Certificate of Appropriateness—Amended

1933 N. 2ND ST. Brewers Hill Historic District

6/6/2016 (Amended 4/17/2017) PTS ID 111313 COA Build Stoop at side entry

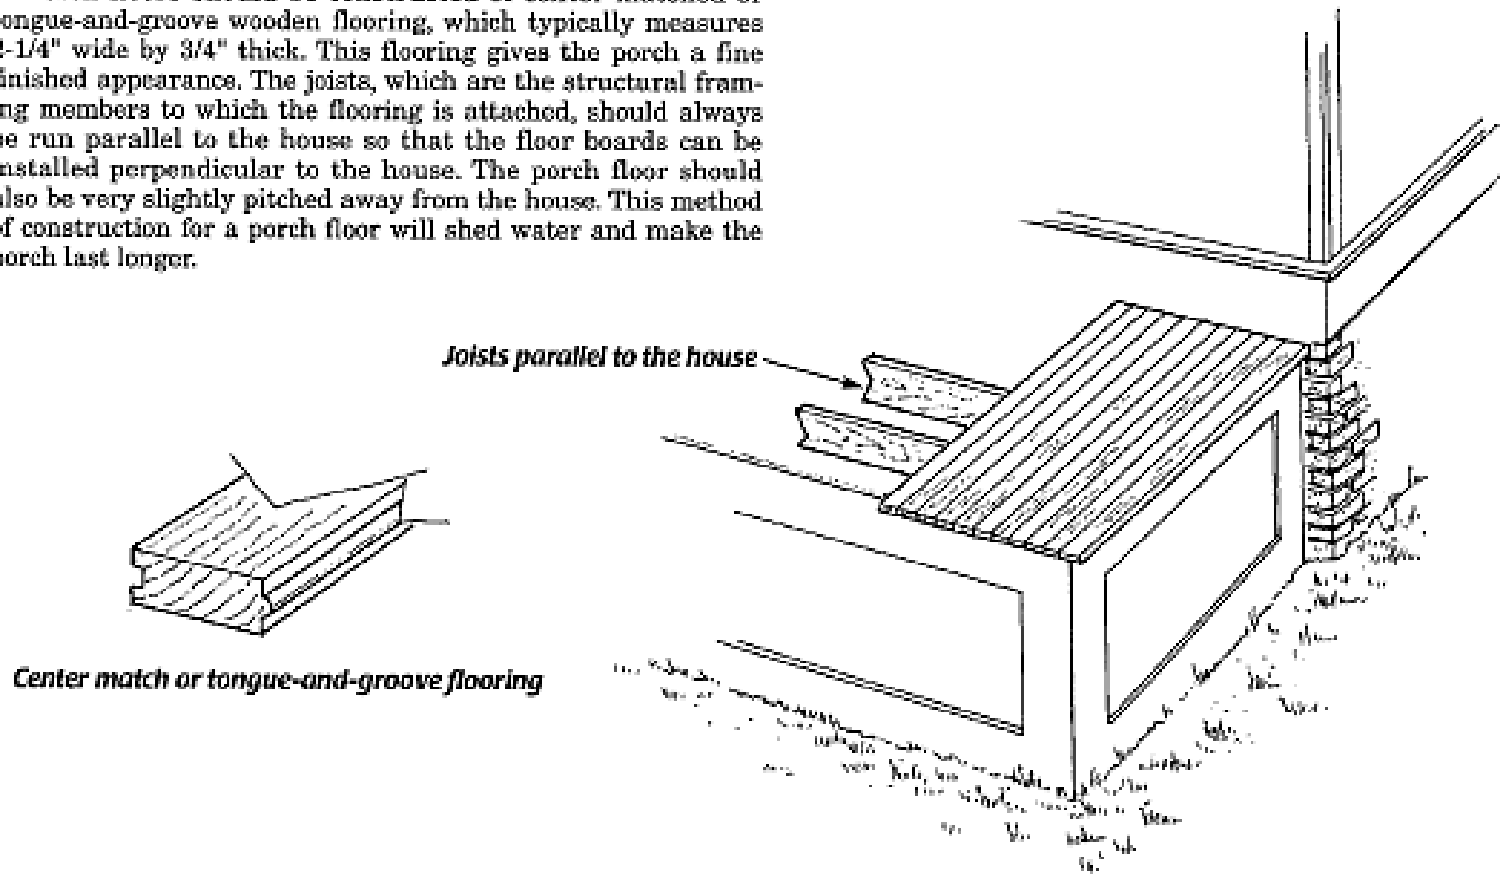
Current conditions showing current stairs that do not meet code.

Location where stoop will be constructed.

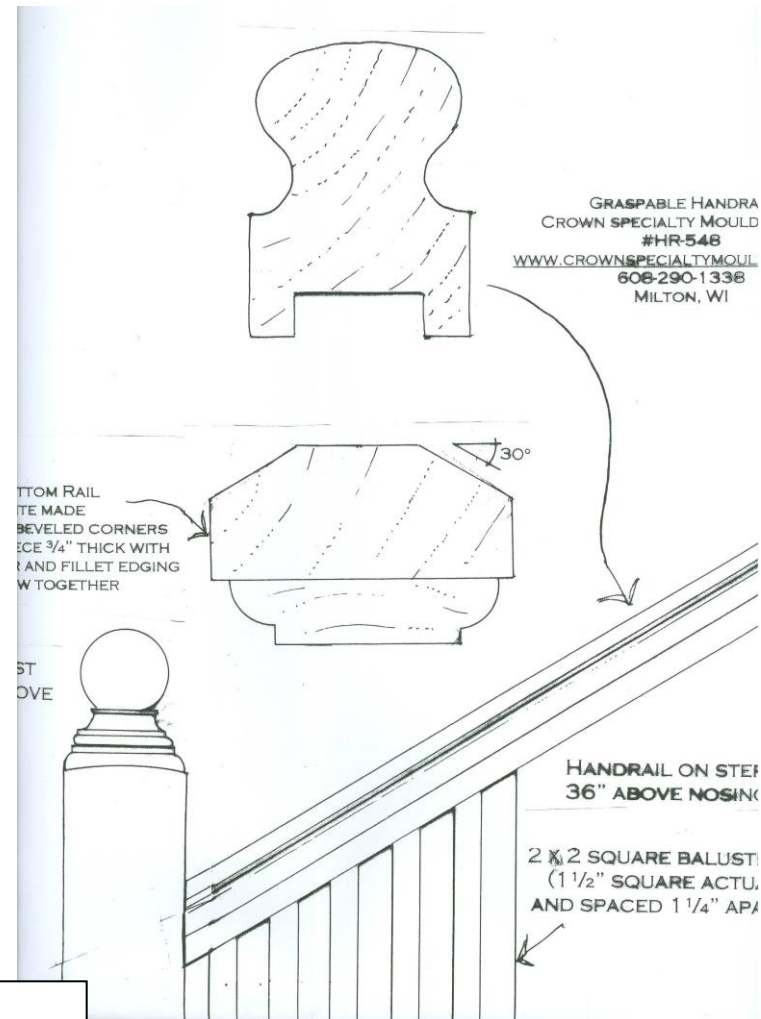
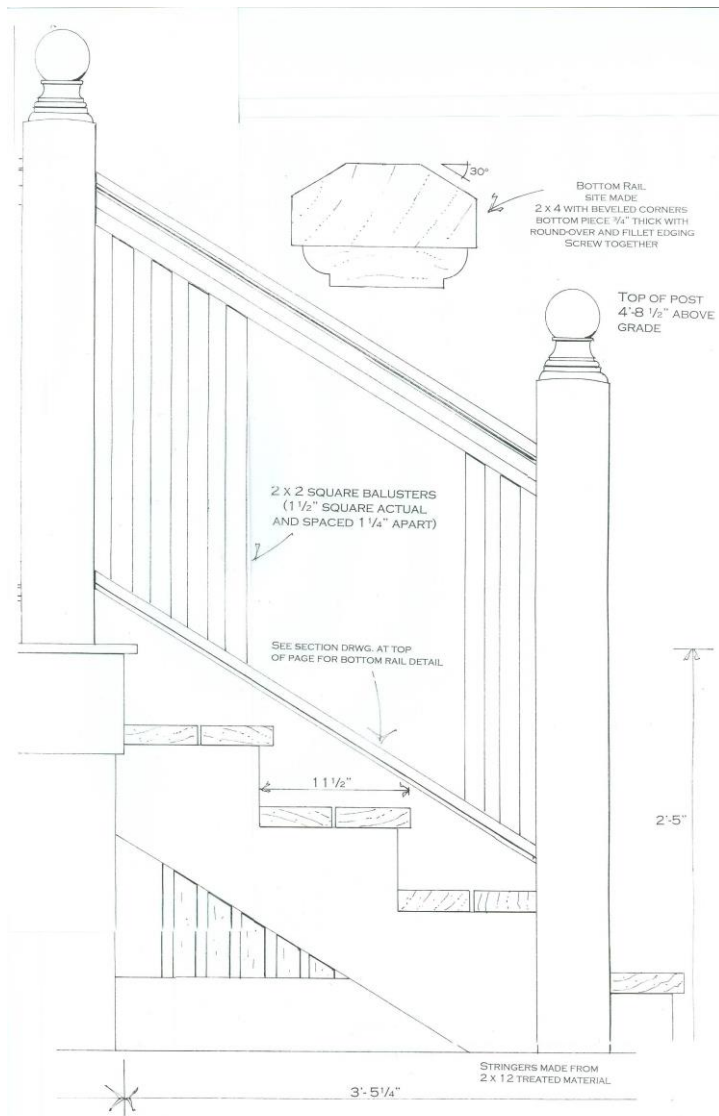
All porches and stoops need a deck on which to stand while using the door.
Note handrail has breadloaf shaped top for easy graspability. Bottom rail is sloped to shed water. Top and bottom rails cannot be simple planks of lumber

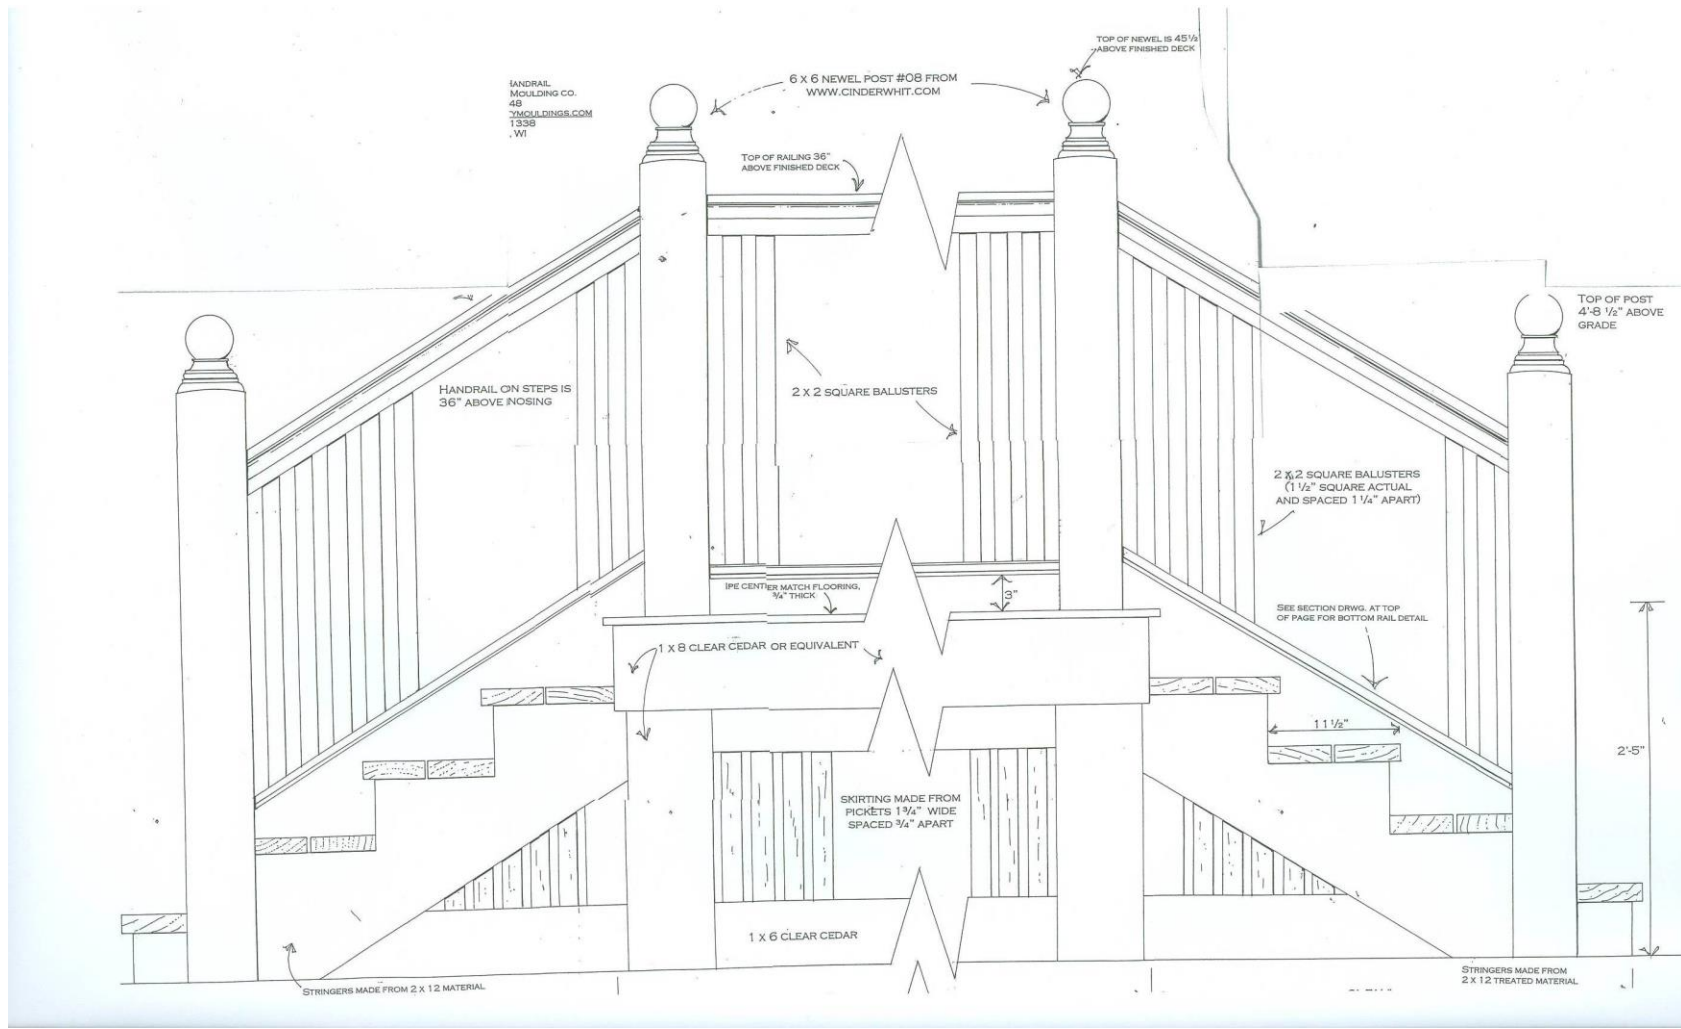
Appropriate simple design for porch and stoop.

Caps on top of posts can be ball-shaped as in this example. Note simple skirting.

Porch Skirting

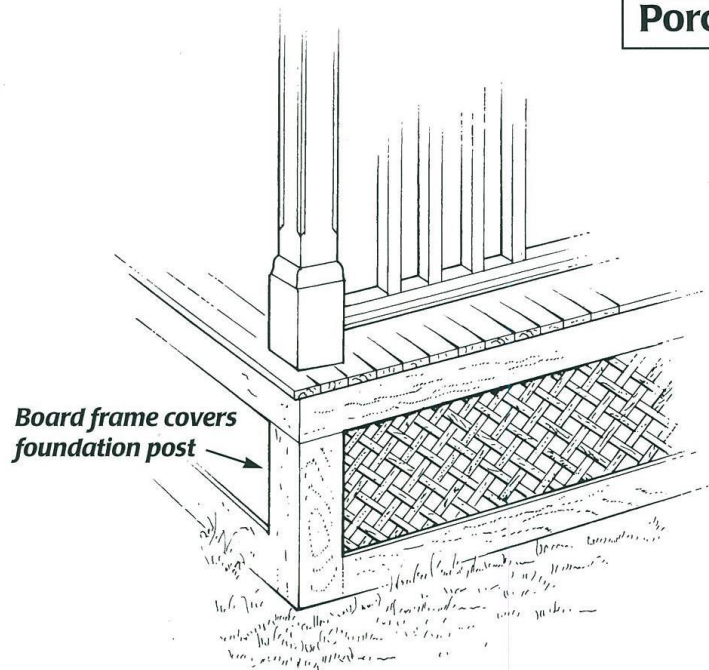
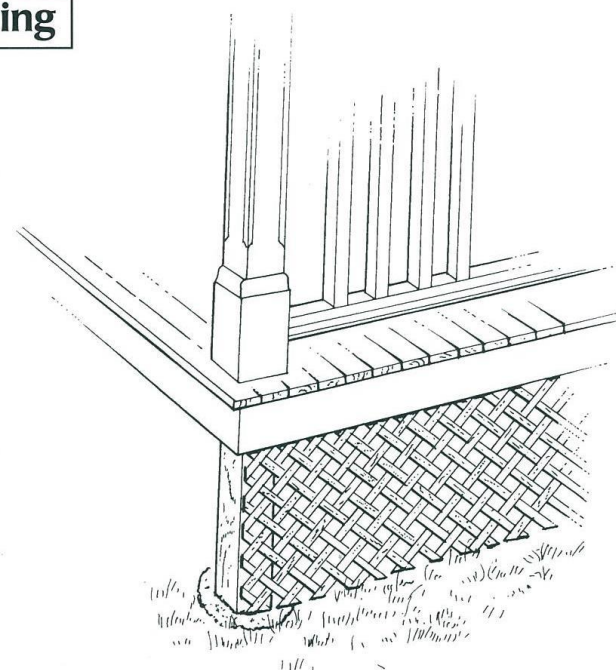
Board frame covers foundation post

Skirting, such as this lattice panel, enclosed the area beneath the porch floor. It should always be installed with a continuous board frame around it that is wide enough to cover the rough framing lumber that supports the porch deck.

Do not install a lattice skirting without a frame around it. The rough framing lumber that supports the porch will show through and the raw edges of the lattice look unfinished.

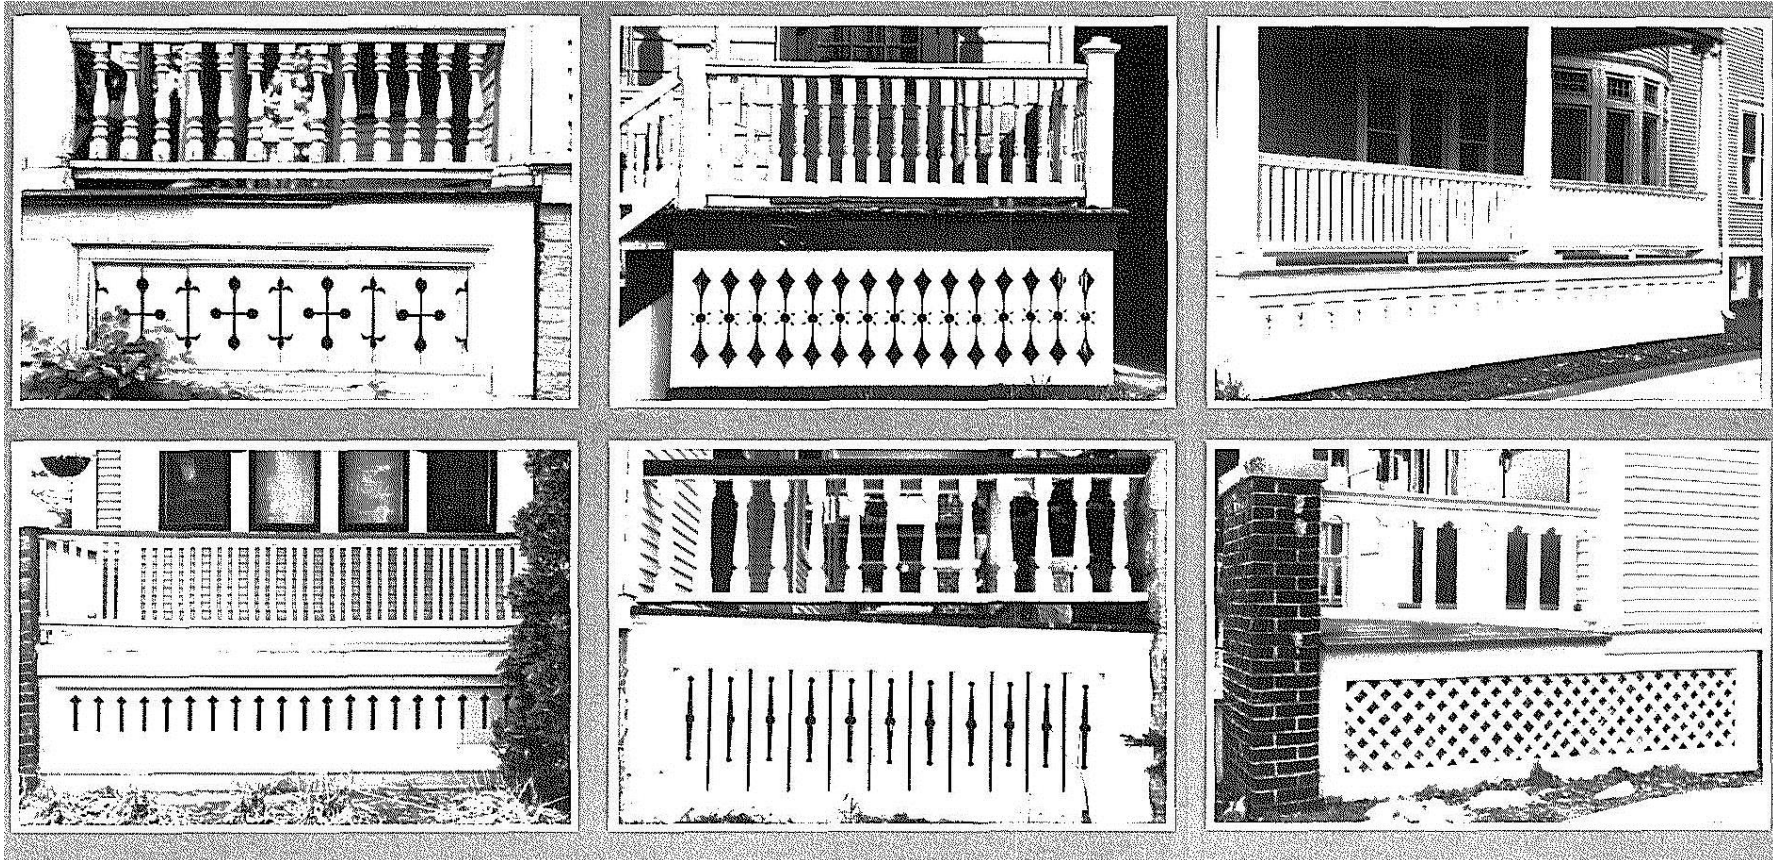
Corner boards are required as in in the "Yes!" column.

A FEW OF THE DOZENS OF HISTORIC SKIRTING DESIGNS FOUND IN MILWAUKEE

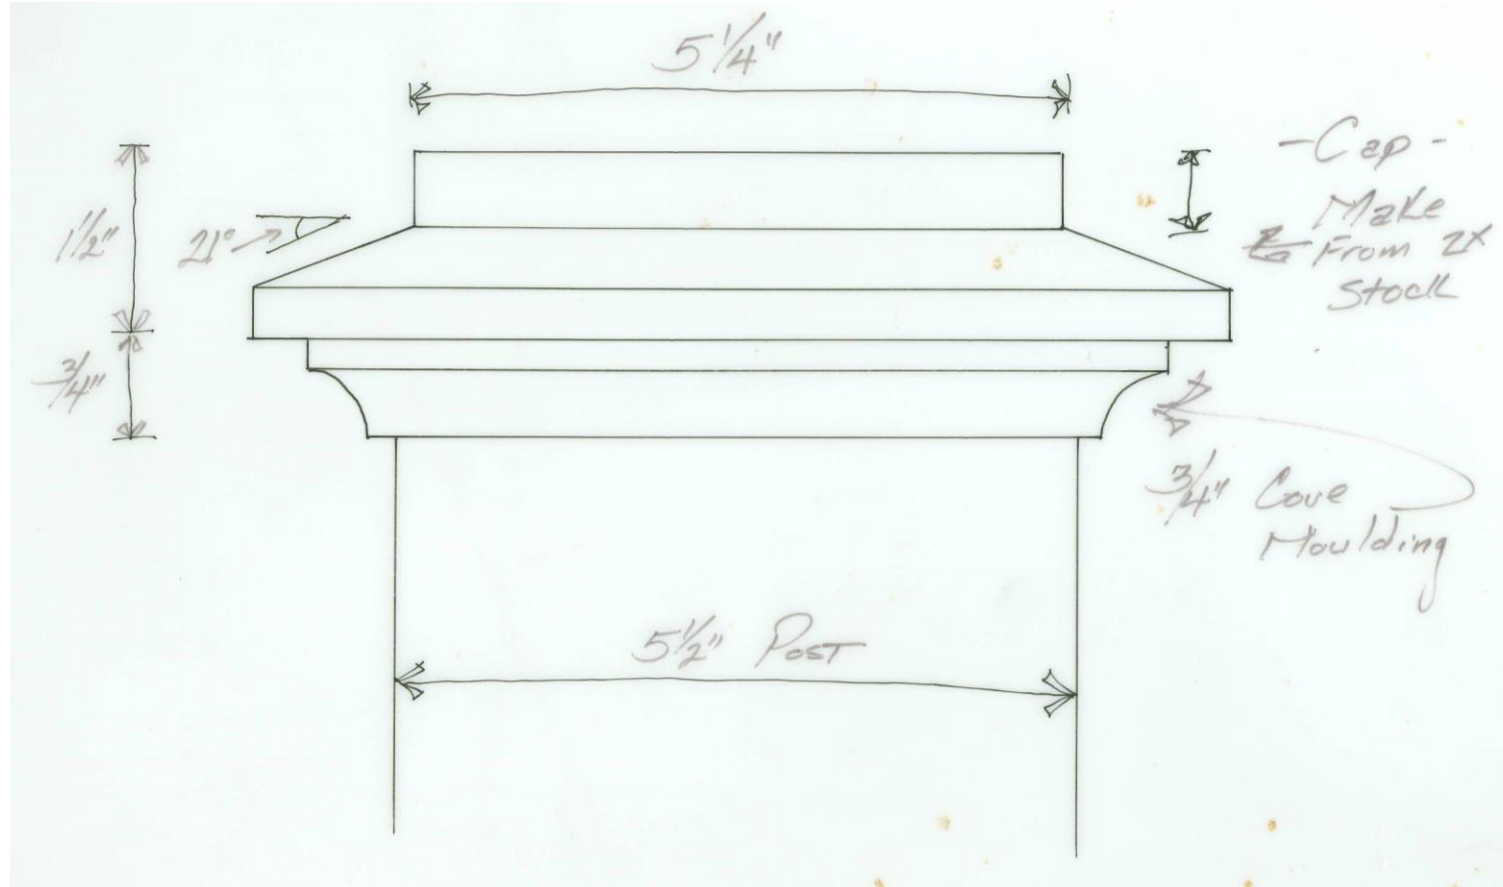
Skirting options. Note that corner boards are required unless using brick posts and lattice skirting must be framed regardless.

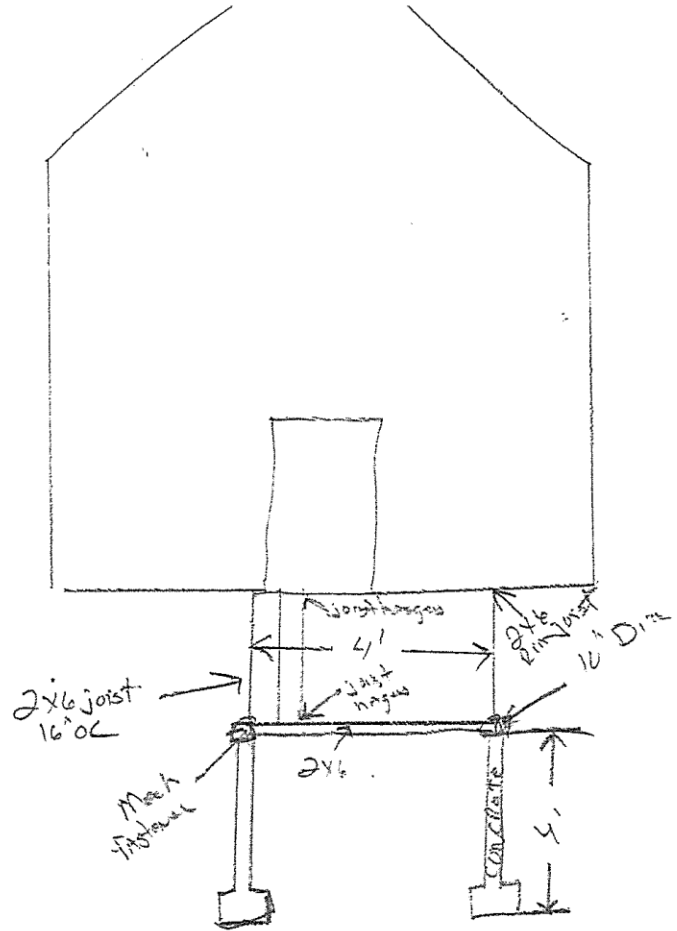
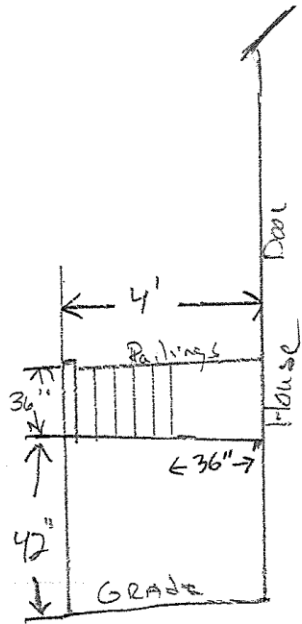
Tops of posts can also be square as in this example or match the ball type on pages 5-6, other options to follow. Note use of cove molding.

These are additional options for the finial. Complex posts are not required. Simple, square, second from the left type of post is sufficient (see pages 5-6).
